ADDENDUM NO. 3

DATE OF ISSUANCE:	April 25, 2024
PROJECT:	2024 Addition and Renovations North Harrison Elementary School 1115 W. Whiskey Run Road Ramsey, IN 47166
OWNER:	North Harrison Community Schools
ARCHITECT'S PROJECT NO.:	23-228.001
ORIGINAL BID ISSUE DATE:	April 03, 2024

SHEET NUMBER
A 601
23-228.001

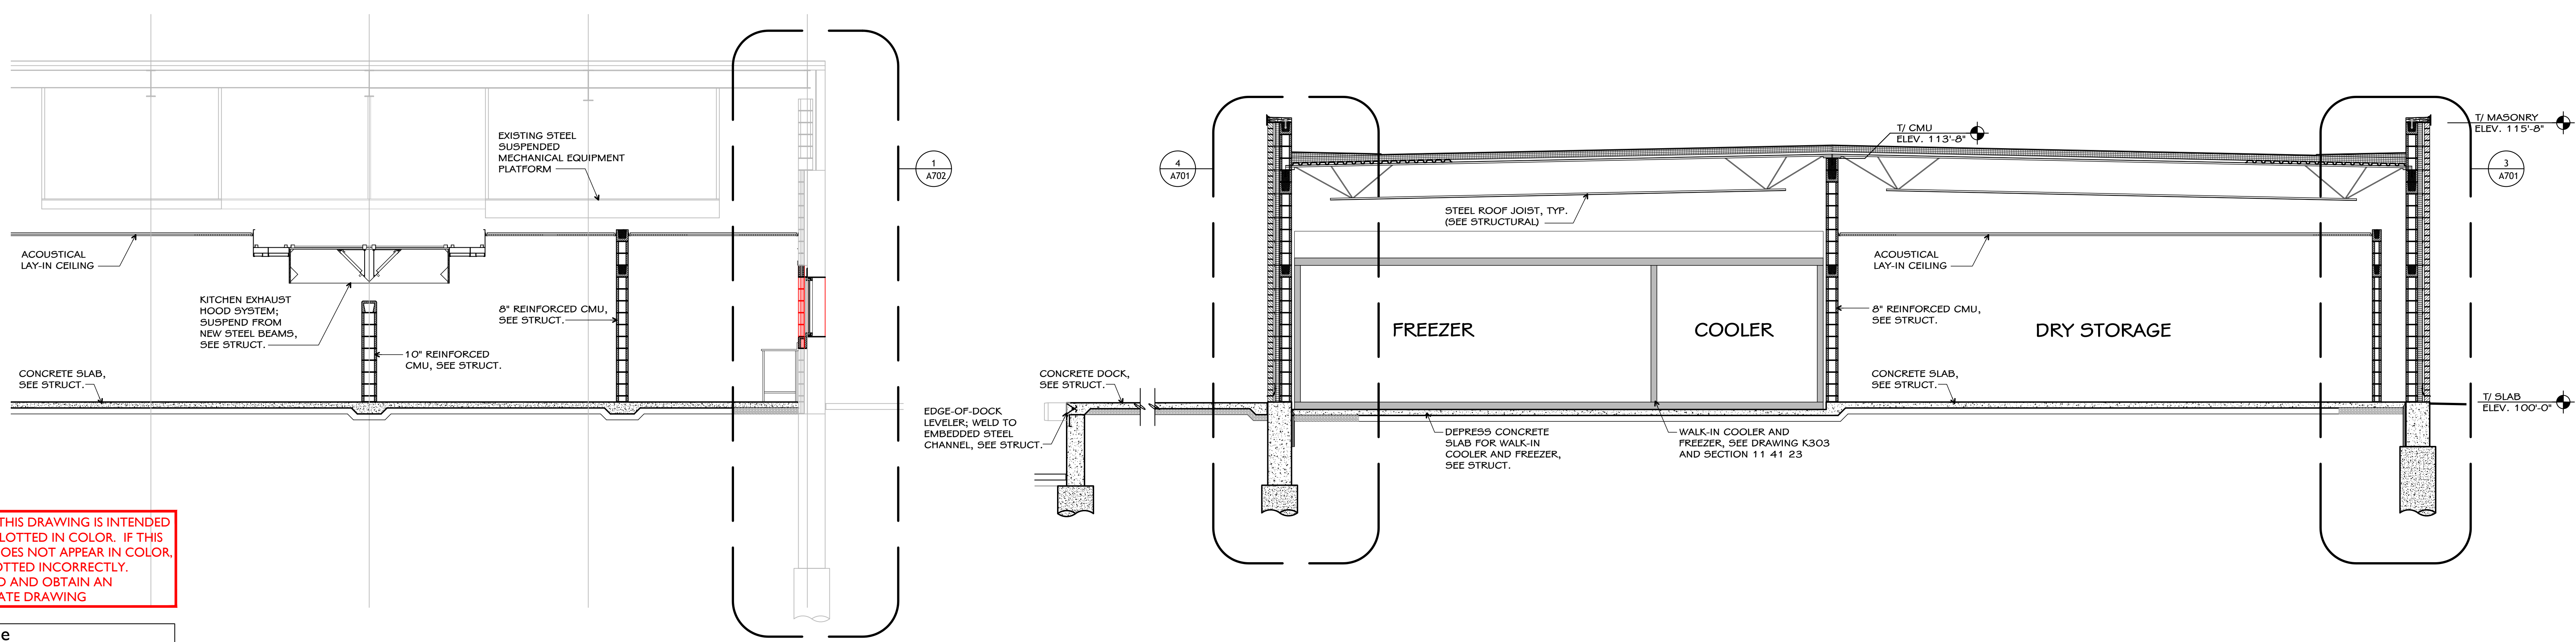
ADD-3 Item No. D-4 - Cafeteria Building Section

Refer to Sheet(s): **A601**

Replace with attached revised Drawing in its entirety; revisions have been clouded for reference. Light fixtures and notations have been added.

PARTIAL FIRST FLOOR PLAN - ELECTRICAL DEMOLITION - AREA A
SCALE: 1/4" = 1'-0"
1
E200A

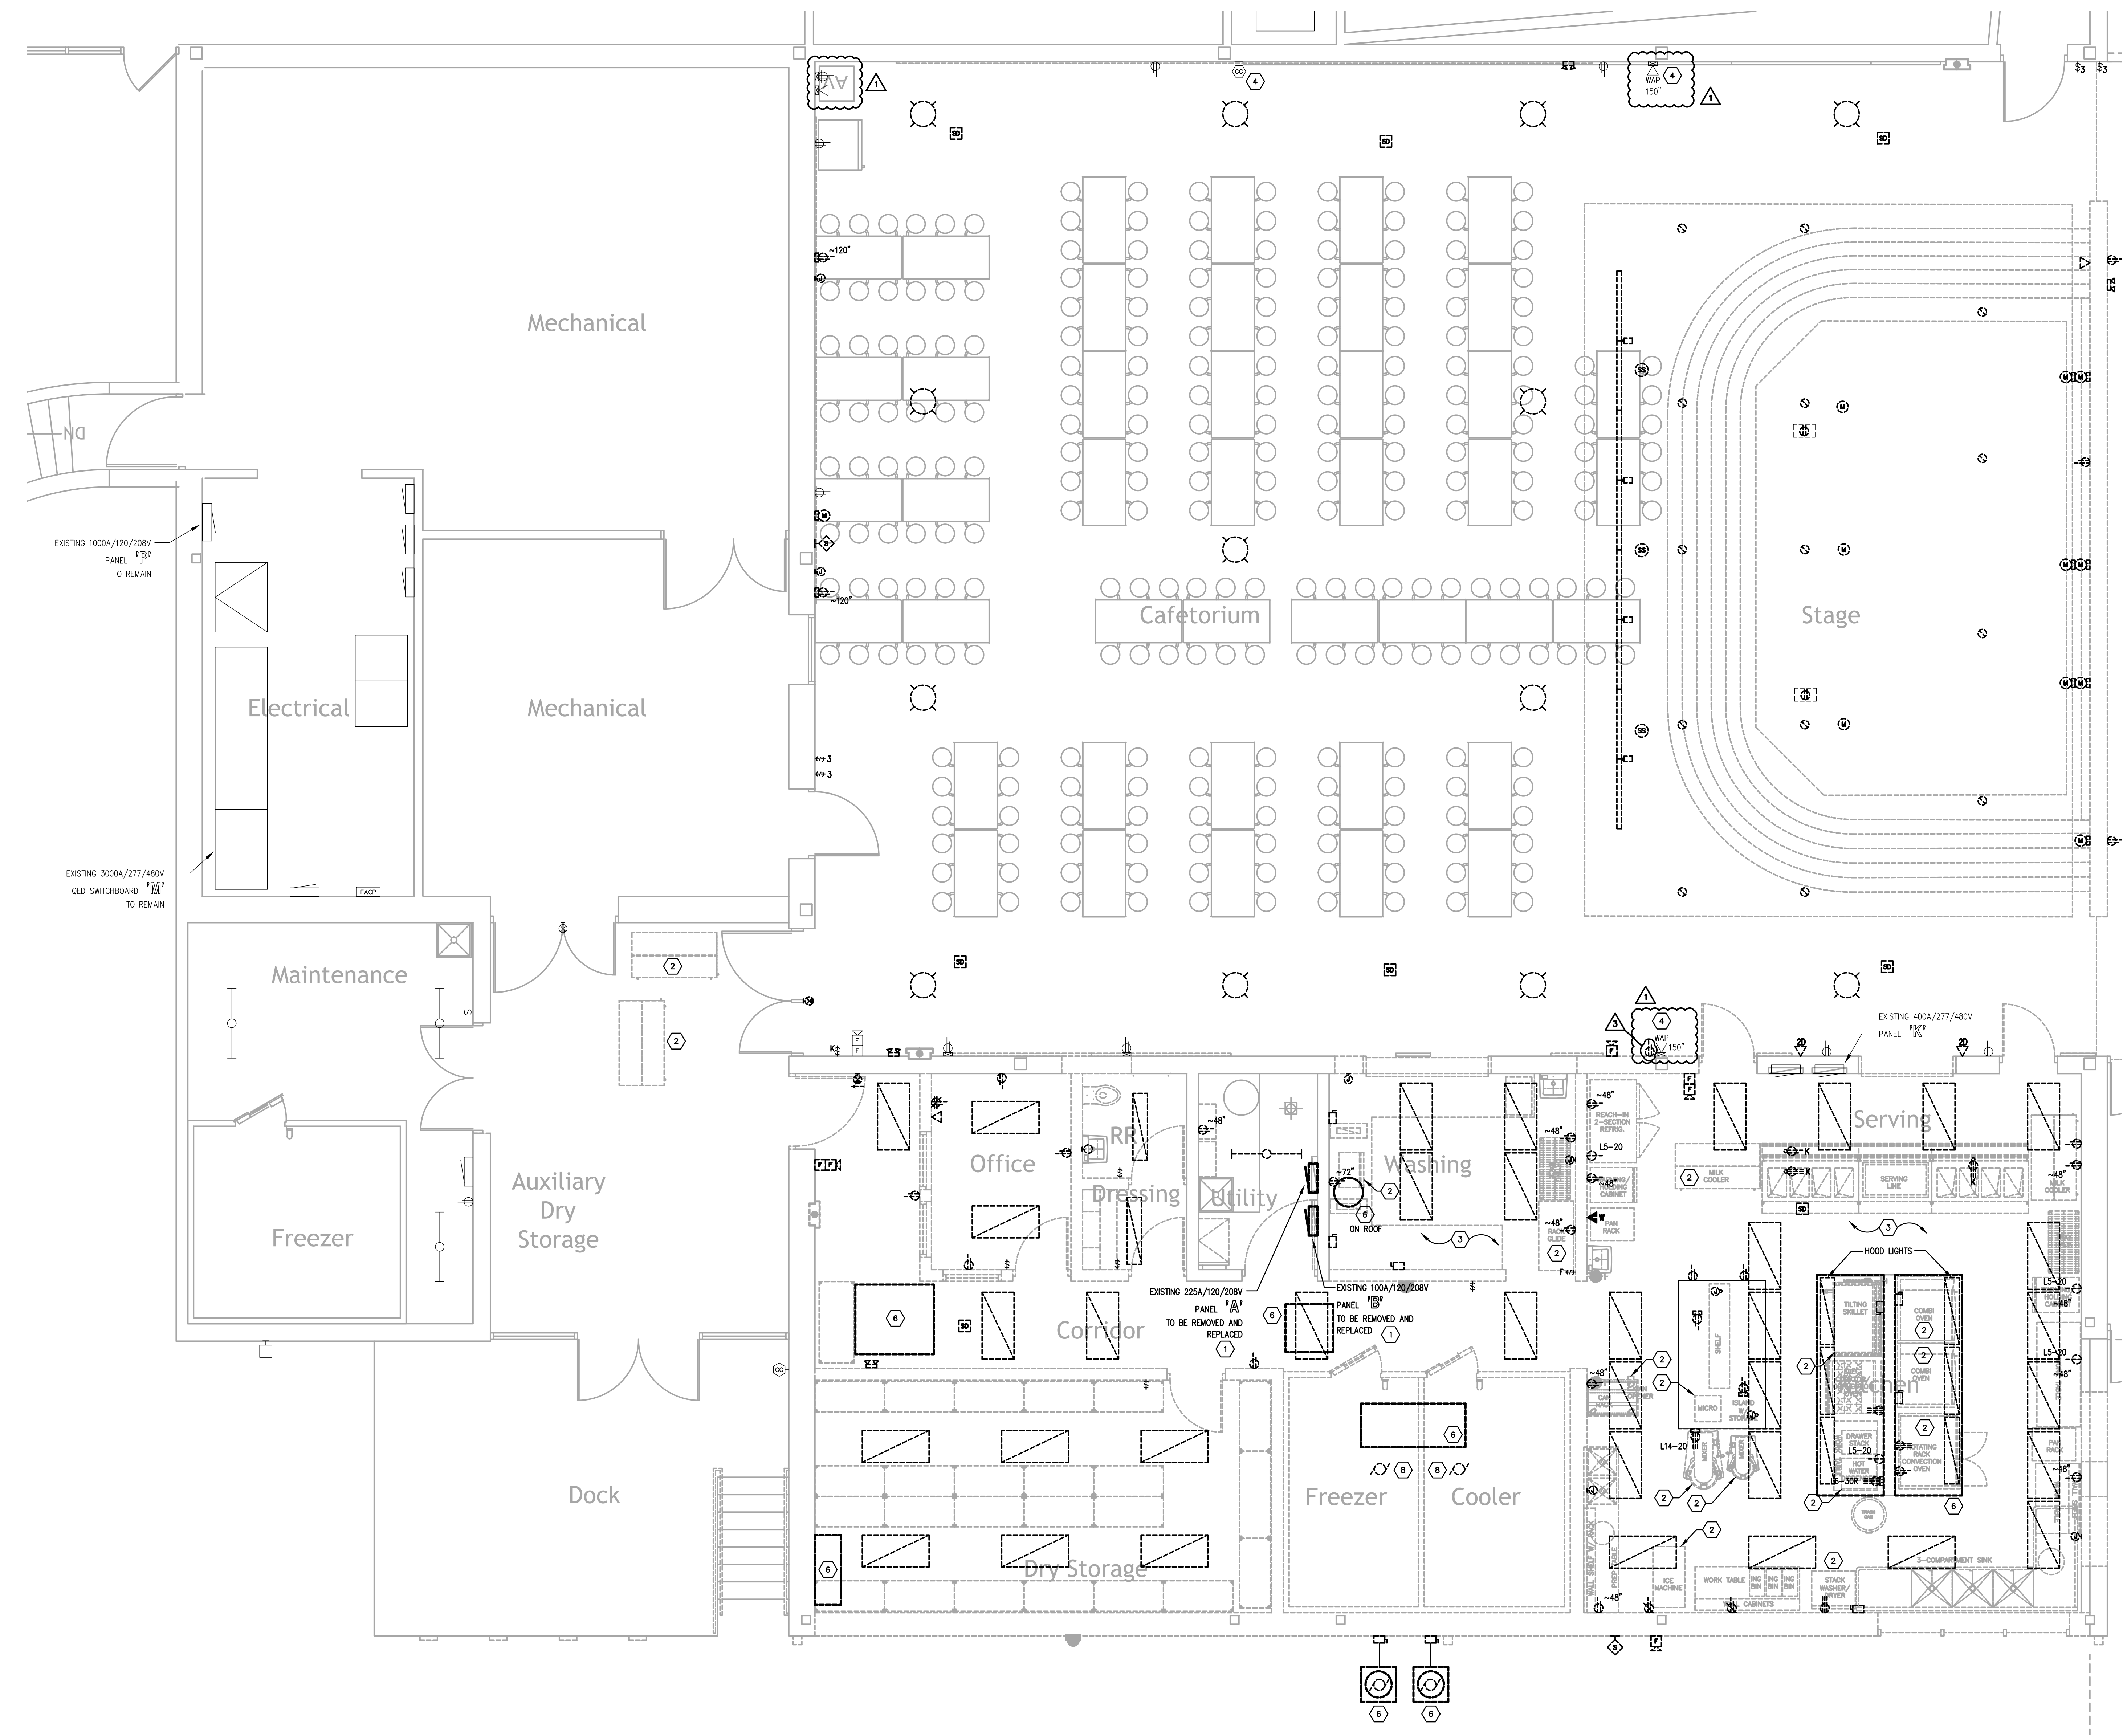
ADD-3 Item No. D-9 - Updated Demolition Scope

Refer to Sheet(s): **E200A, E400A**

Duplex along south wall of Cafeteria 133 to be demolished. Updated scope is as shown on attached sheets.

PARTIAL FIRST FLOOR PLAN - POWER/SYSTEMS - AREA A
SCALE: 1/4" = 1'-0"
E400A

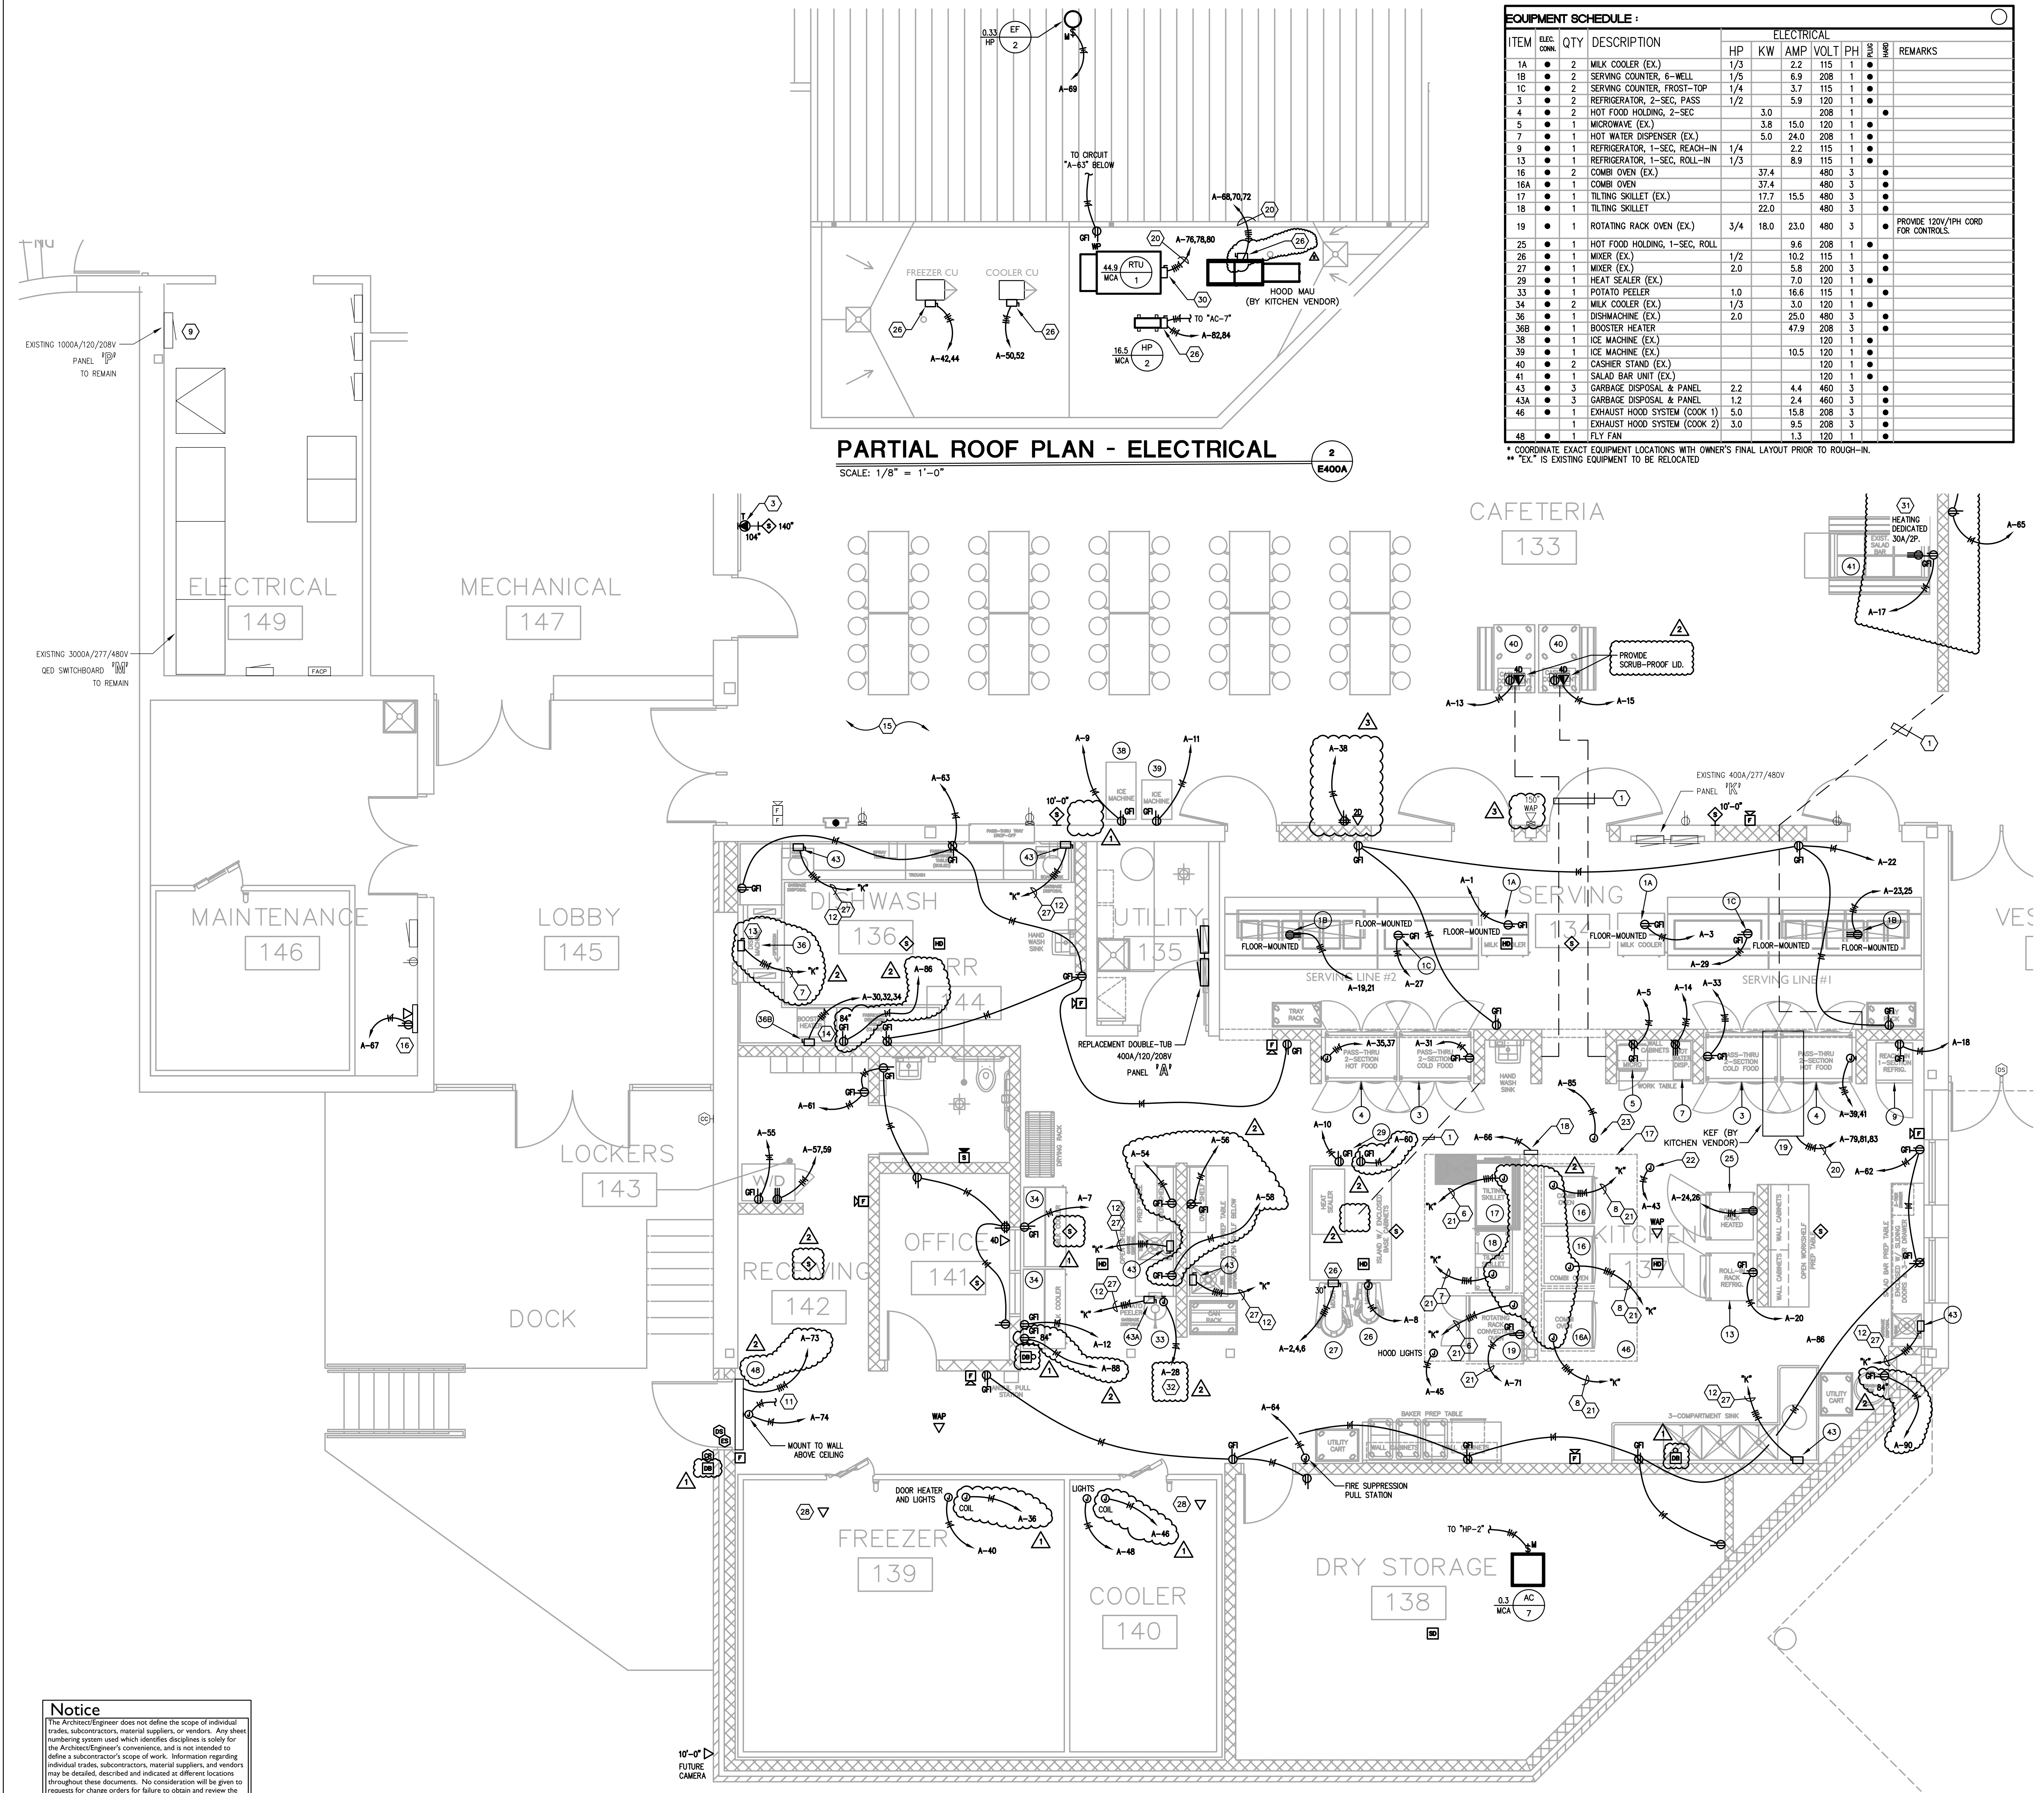
ADD-3 Item No. D-8 - Employee Timeclock Power/Data

Refer to Sheet(s): **E400A**

Added a quadruplex and 2-data outlets on south wall of Cafeteria 133 for employee timeclock connections. Circuit quadruplex to "A-38". Route (1) #12 conductor and (1) #12 ground in 3/4" conduit to panel indicated.
